Re: St. Lucie Plant Unit 1  
Docket No. 50-335  
Renewed Facility Operating License No. DPR-67

Response to NRC Reactor Systems Branch and Nuclear Performance Branch  
Request for Additional Information Regarding Extended Power Uprate License  
Amendment Request

**Response to  
NRC Reactor Systems Branch and  
Nuclear Performance and Code Branch  
Request for Additional Information  
Regarding Extended Power Uprate  
License Amendment Request**

### **Response to NRC Reactor Systems Branch and Nuclear Performance and Code Branch Request for Additional Information Regarding Extended Power Uprate License Amendment Request**

**Figure 11: High Energy Line Break (No Motor-Driven AFW Pumps): Pressurizer Liquid Level**

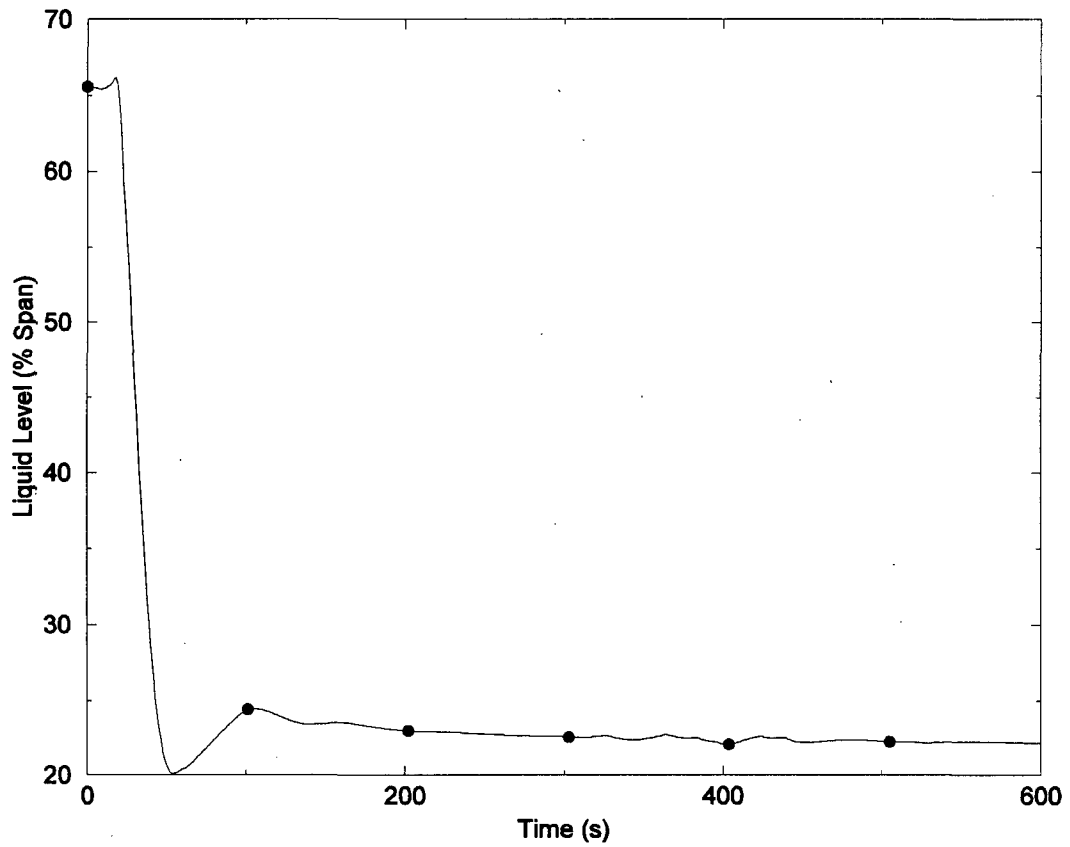
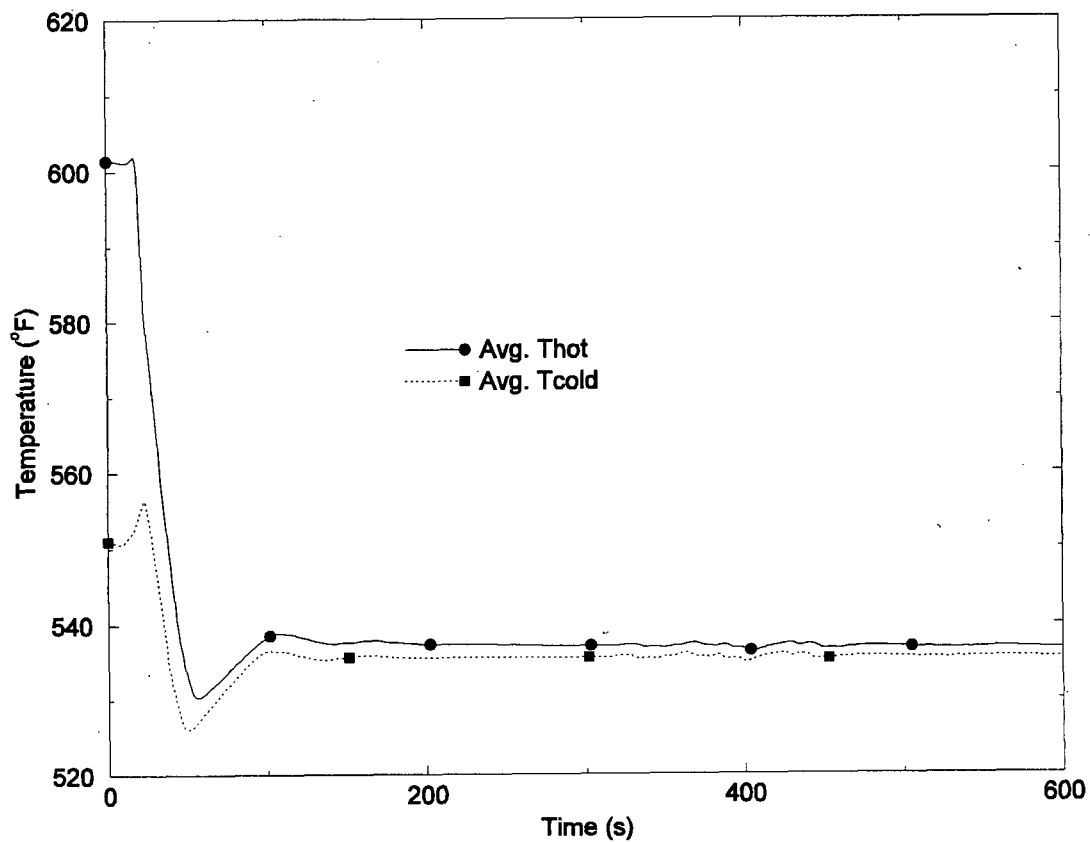
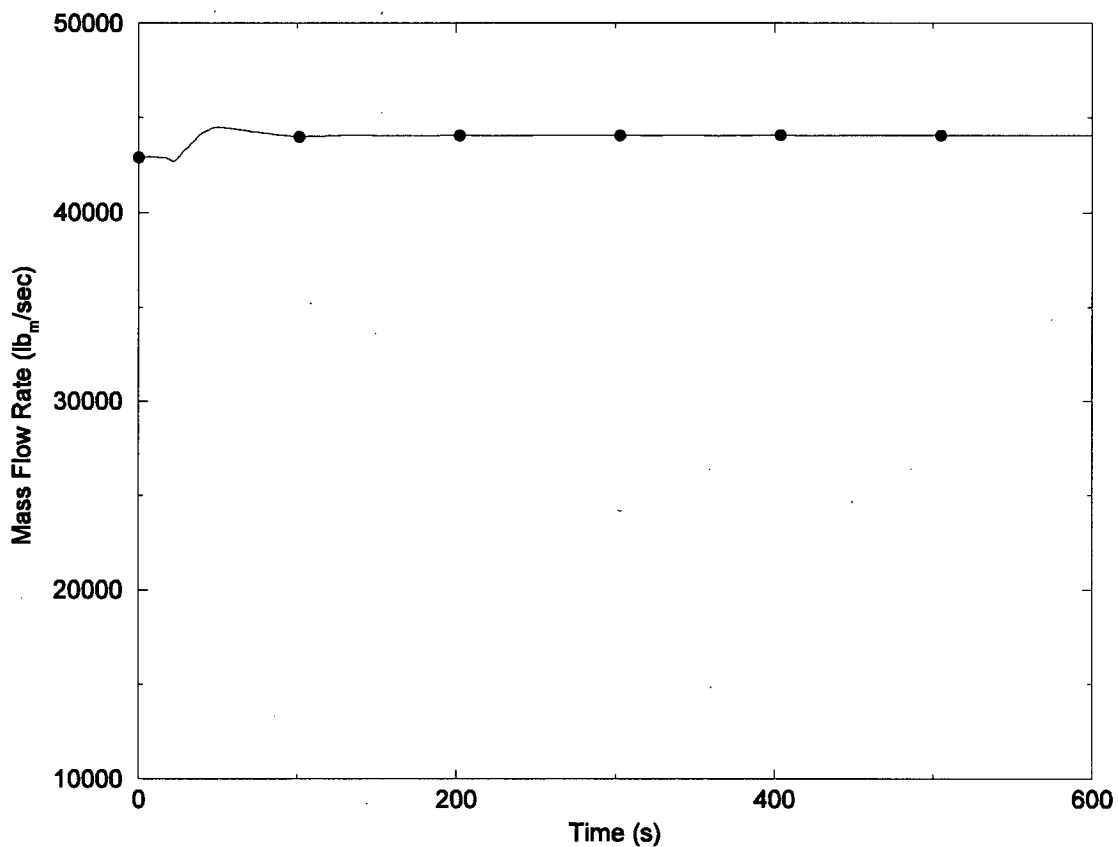
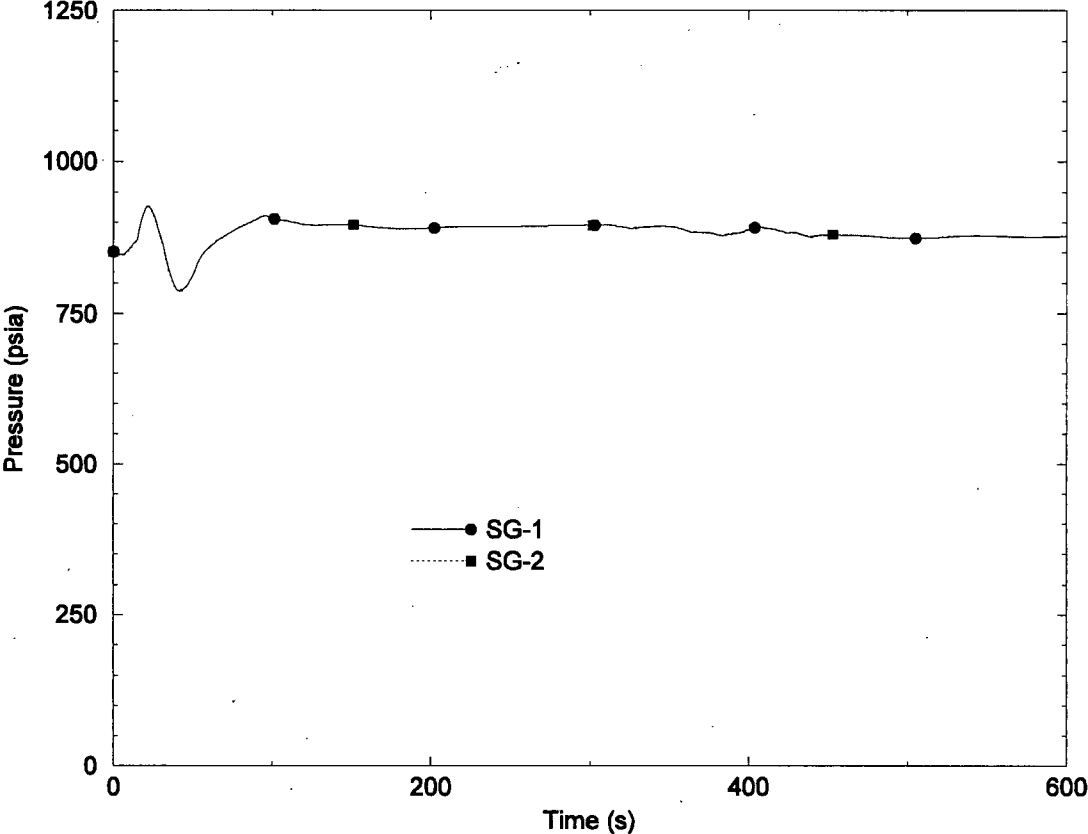
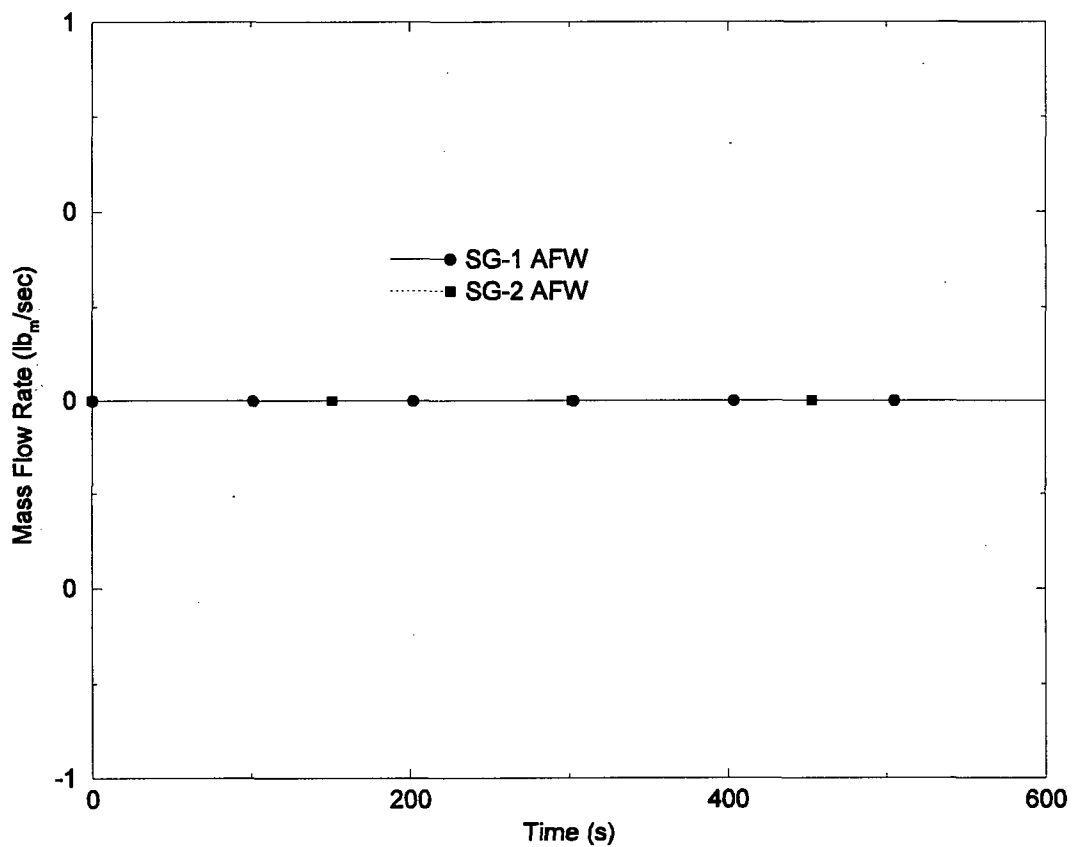
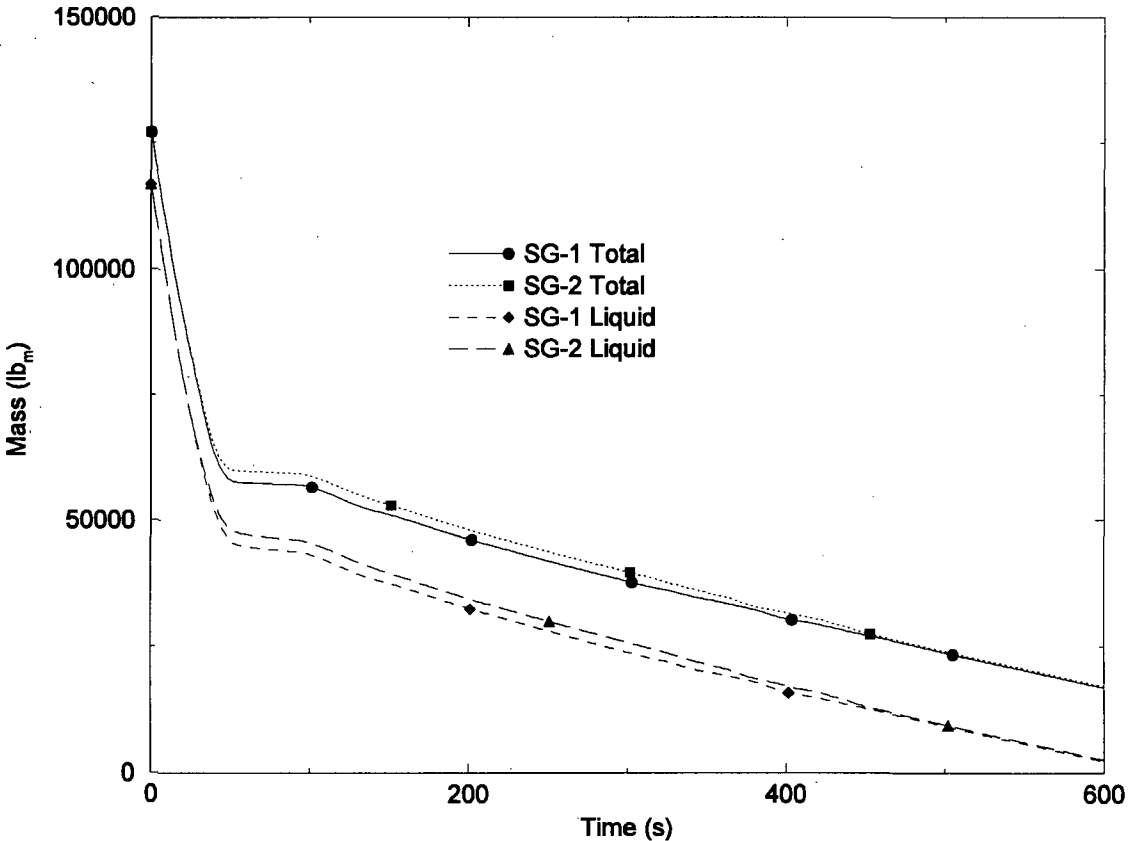
**[2.8.5.2.4.a] The LR states that, “in the St. Lucie Unit 1 licensing basis, the feedwater line break (FWLB) event is defined as a cooldown event that is bounded by the main steam line break (MSLB) event. The key system, subsequent to reactor trip, for mitigating the post-scrum MSLB event is the Safety Injection System, which injects boron into the RCS to arrest the post-scrum return-to-power (See LR Section 2.8.5.1.2). The same mitigating systems apply to both MSLB and FWLB.”**

**Defining the FWLB as a cooldown event eliminates the FWLB from consideration as a Condition IV design basis accident (DBA). When analyzed as a heatup event, the FWLB tests fuel and RCPB integrity, and helps set the performance requirements for the AFWS. The Safety Injection System, particularly its reactivity control function, does not mitigate the FWLB, when considered as a heatup event.**

**The FWLB is a limiting fault, in the “decrease in heat removal by the secondary system” category in Table 15-1 of RG 1.70. It is necessary to identify the FWLB as a limiting fault in the heatup category, and provide analyses of the worst cases in the current licensing basis, and in the LR that supports the proposed EPU.**

**According to the specific review criteria in SRP Section 15.2.8, and the guidance in Matrix 8 of RS-001, FWLBs are to be analyzed as heatup event. As such, FWLBs are in the class of events that are directly affected by an increase in authorized power level. The LR conclusion, that the plant will continue to meet the requirements of GDC 27 and GDC 35, following implementation of the proposed EPU, is not supported by analysis.**

**Provide an analysis of the FWLB, considered as a heatup event, according to the specific review criteria in SRP Section 15.2.8 and the guidance in Matrix 8 of RS-001.**

The results of this analysis are summarized in Table 3. The transient sequence of events is shown in Table 2, and the transient results are shown in Figure 1 to Figure 8. The results demonstrated that the degraded AFW system capacity and actuation setpoint are adequate to maintain primary-to-secondary heat transfer such that the plant can be stabilized and brought to a safe shutdown in a controlled manner. Adequate cooling was maintained through the vaporization of the AFW and the pressurizer steam space was preserved. There was no significant heatup of the primary system. Thus, all acceptance criteria are satisfied for this event.

The results of this analysis are summarized in Table 3. The transient sequence of events is shown in Table 2, and the transient results are shown in Figure 9 to Figure 16. With no automatic initiation of AFW flow, there is ample time (more than 10 minutes after event initiation) for the operators to start the turbine-driven AFW pump prior to losing subcooling margin and filling the pressurizer.

Figure 47-1 RWT Temperature – Plant Data and RLBLOCA Analysis Value

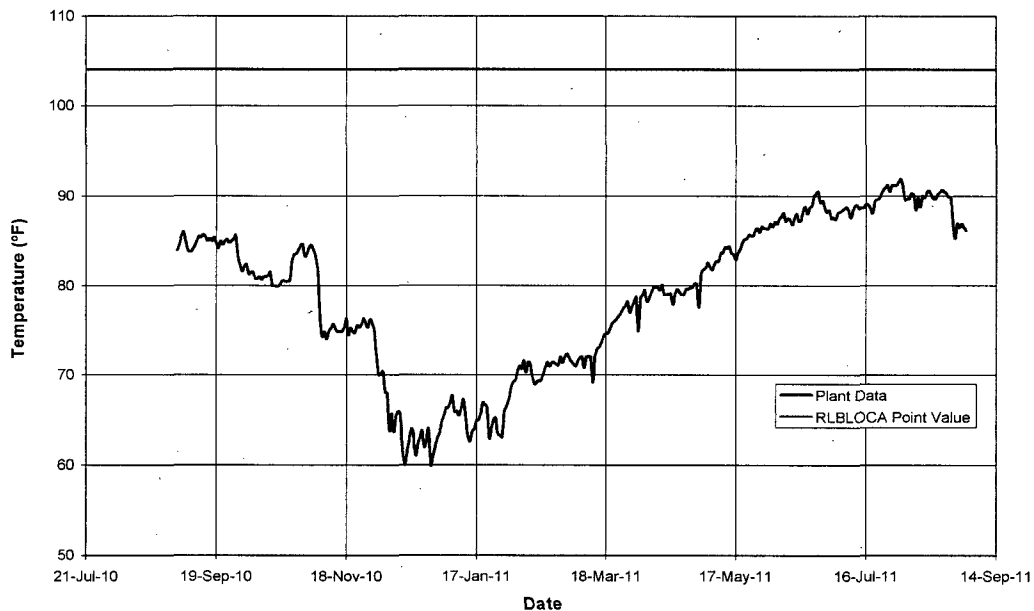
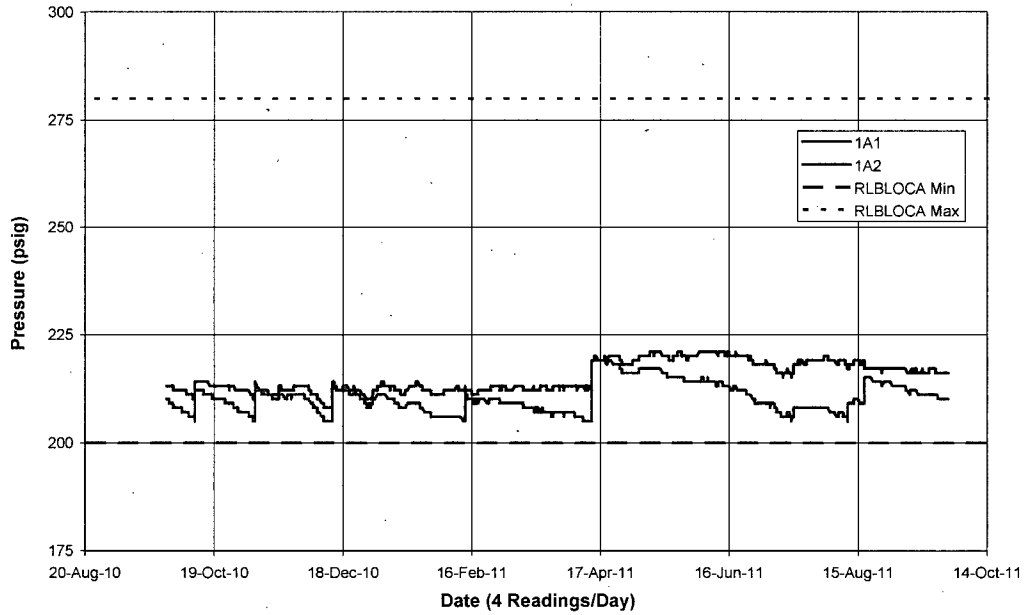
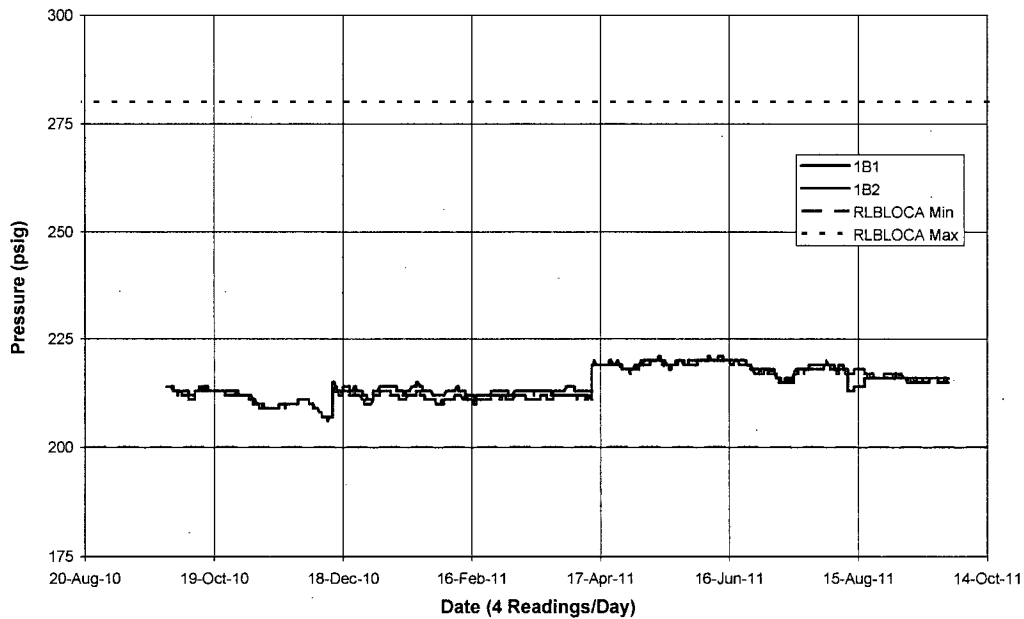
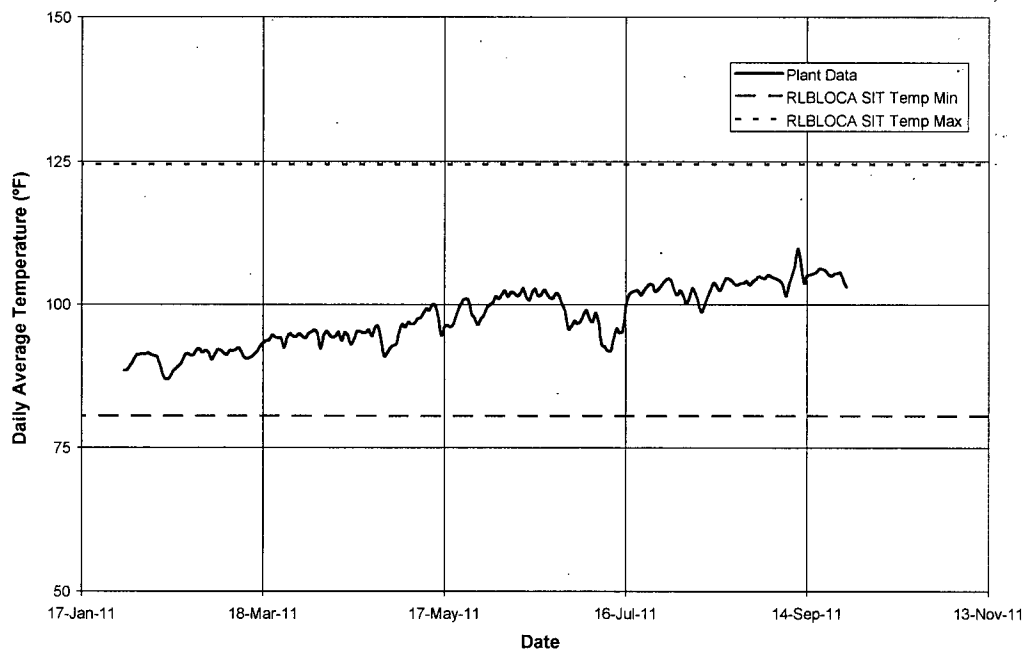
**Demonstrate the validity of the sampling functions for safety injection tank cover pressure, safety injection tank temperature, and RWST temperature by providing a histogram of observed pressures and temperatures collected from recent surveillance data that can be compared to the Figure 3-6 scatter plots of these sampled parameters. For RWST temperature please also provide a scatter plot similar to those in Figure 3-6.**

The safety injection tank (SIT) pressure is sampled from 200 psig to 280 psig to cover the range of SIT pressures as presented in section 3.5.1 of the current Technical Specifications (TS) and as presented in St. Lucie Unit 1 EPU LAR Attachment 1, section 3.1, item 17 "TS 3/4.5.1, EMERGENCY CORE COOLING SYSTEMS (ECCS) – SAFETY INJECTION TANKS (SIT)" which conveys the proposed TS. The SIT temperature is sampled with a uniform distribution over the range of 80.5 °F - 124.5 °F (Technical Specification 3.6.1.5<sup>1</sup>). The RWT temperature is not sampled; it is set to 104 °F (Technical Specification maximum plus uncertainty, Technical Specification 3.5.4). Table 3-3 in ANP-2903(P) Rev. 1 (Attachment 2 of Reference 1) provides the RWT temperature and shows that this is a point parameter, not a ranged parameter. Figure 47-1 through Figure 47-4 show the RLBLOCA analysis values along with the St. Lucie Unit 1 plant data.
